## Record of Executive Business and Chief Executive's Order

### PR/1459/21

**Reg. Reference:** SD21A/0051      **Application Date:** 03-Mar-2021  
**Submission Type:** Additional      **Registration Date:** 13-Oct-2021  
Information

**Proposed Development:** The continuance of use of the existing 3 buildings and all associated external areas for storage and warehousing of motor vehicles, plant, machinery and other durable products for the sale by public auction, all associated ancillary uses including support staff and office facilities and all associated site and development works comprising hard and soft landscaping areas, roads and footpaths, car parking, boundary treatments/ fencing, signage and water services infrastructure. The development described above was previously permitted under Reg. Ref. SD18A/0126 and the duration of the permission was limited to two years by condition 9 of that permission. A Protected Structure - Former Gun Powder Store (RPS Ref. 205) - is located within the application site.

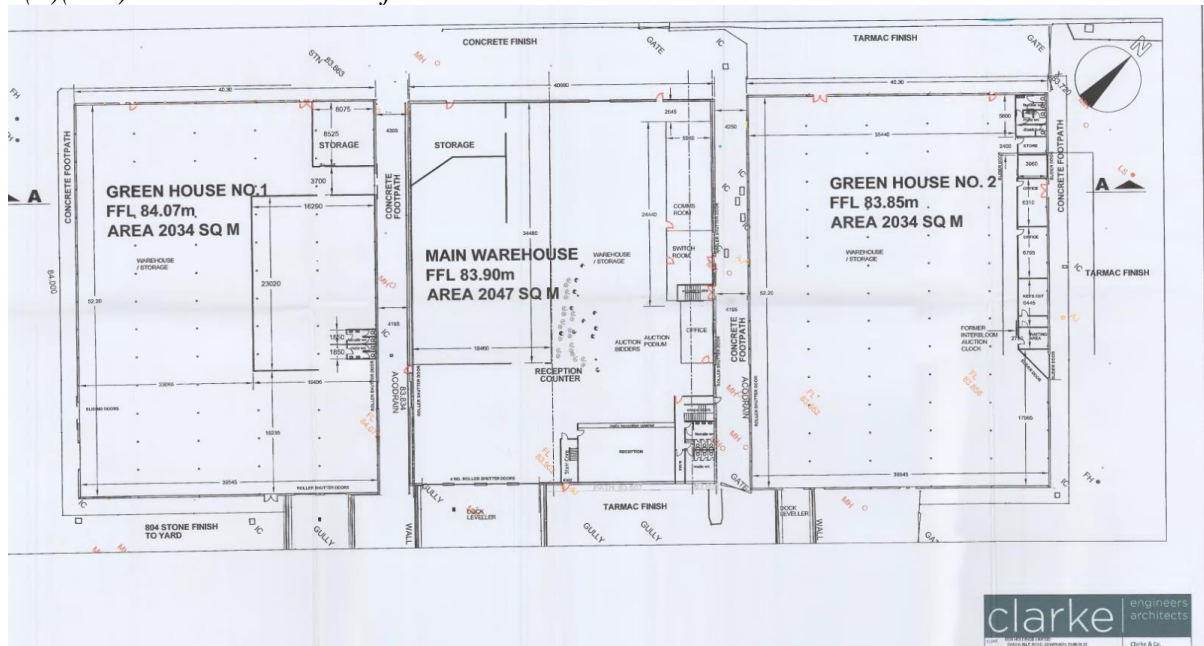
No new uses are proposed. Permission previously granted for “storage and warehousing of motor vehicles, plant, machinery and other durable products for sale by public auction”. These are in keeping with ET3 SLO2 uses.

Auctions are ancillary, as confirmed by the limited area of the development devoted to auction uses, i.e. part of the central Main Warehouse as identified on the enclosed ground floor plan (dwg no P05).

The floorplans indicate a small area of the main warehouse dedicated to the auctioneering and has set out that online auctioneering also takes place. In terms of footprint taken up on site, it is apparent that the auctioneering is ancillary to the warehouse / storage use. The times that the auctions take place are also limited and should planning be granted, a condition is recommended restricting the times/number of onsite auctions can take place. The applicant has therefore addressed items (a)(i), (a)(ii), (a)(iii) adequately. In terms of (a) (iv) the applicant has not provided details of concurrent auctions, however, it is noted that there is a single podium and therefore only a single auction can take place at a time. Item (a)(iv) has therefore been addressed adequately. For item (a)(v) the applicant has indicated that there would be any variance of use on days when the auction is taking place verse when there is no auction, as there is no overlap between areas. The information submitted in relation to (a)(vi) regarding Covid is also considered acceptable.

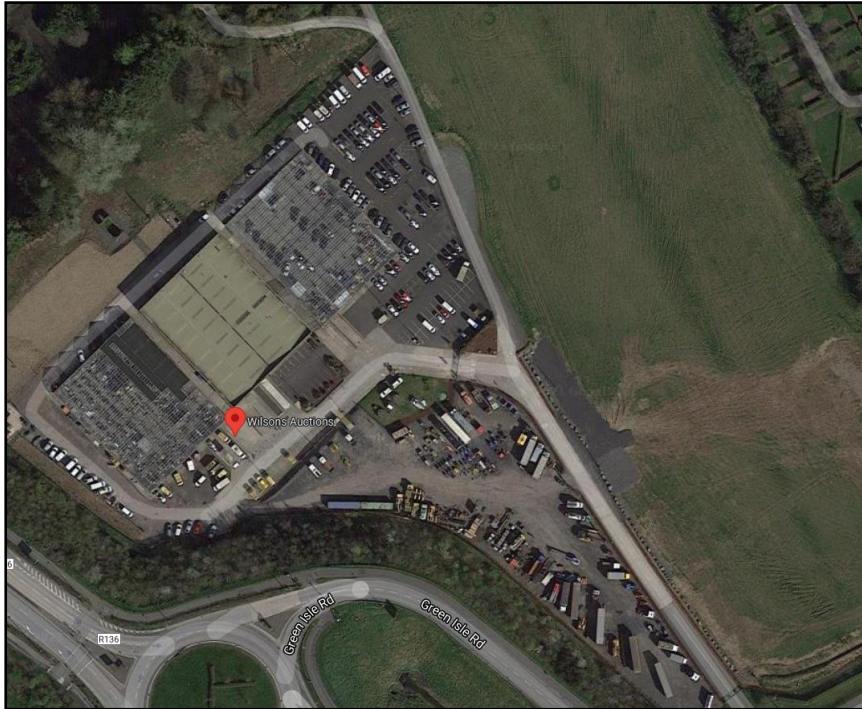
It is apparent from aerial photography that there are areas of hardstanding to the east of the access road:

These areas are not indicated on the hardstanding plan. They are shown as landscaped on other plans. Should permission be granted, then a condition would be imposed seeking restoration of these areas in accordance with the landscape plans.
